From: Carrillo, Abiel X.
To: "Scott Steffen"
Subject: H13D025X - Sawmill Village Phase 2 - SPBP/SPS
Date: Thursday, December 15, 2016 3:45:00 PM

SITE DEVELOPMENT PLAN
FOR BUILDING PERMIT AND SUBDIVISION AMENDMENT
SAWMILL VILLAGE
BELLAMAH AVE NW AND 18TH ST
ALBUQUERQUE, NM

Re: Sawmill Village Grading and Drainage Plan
Engineer's Stamp dated 5-13-08 (H13/D025A)

DRAINAGE
MANAGEMENT
PLAN

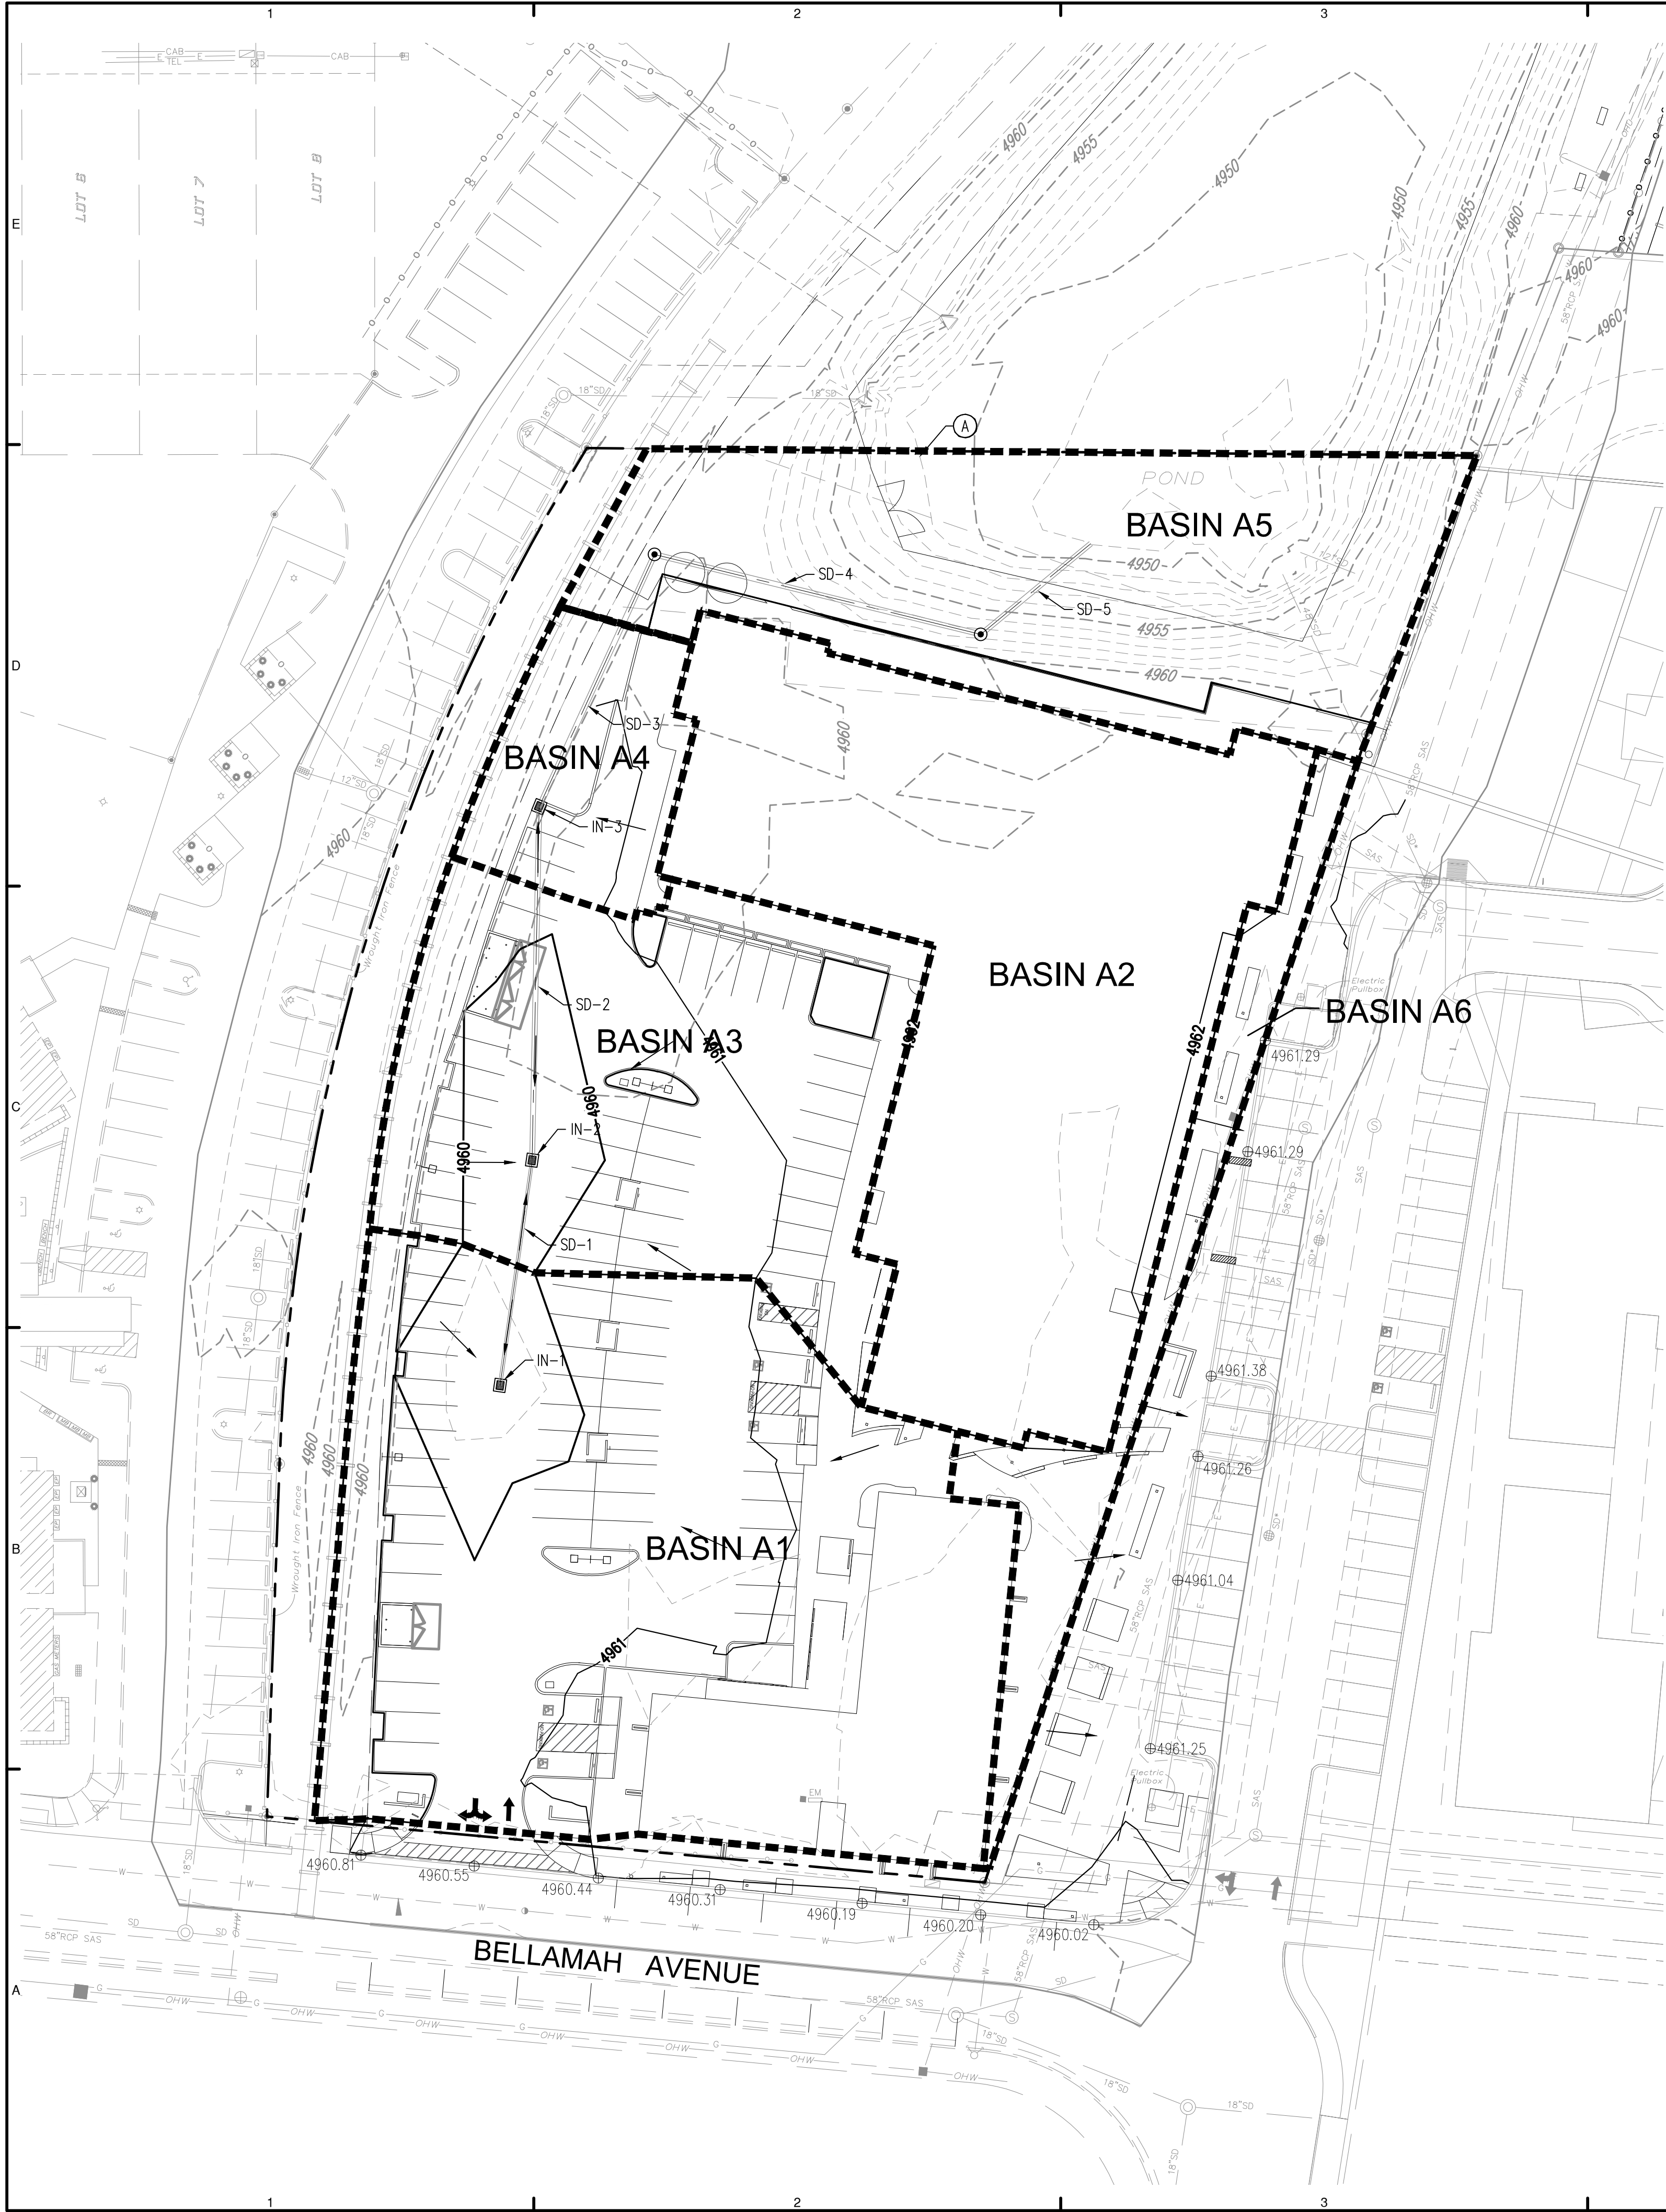
Just to formally closeout the submittal for DRB, the Site Plan for Building Permit and Site Plan for Subdivision Plans received 12-02-2016 are approved with the condition that the Work Order address the need for a curb-height water block at the Bellamah entrance.
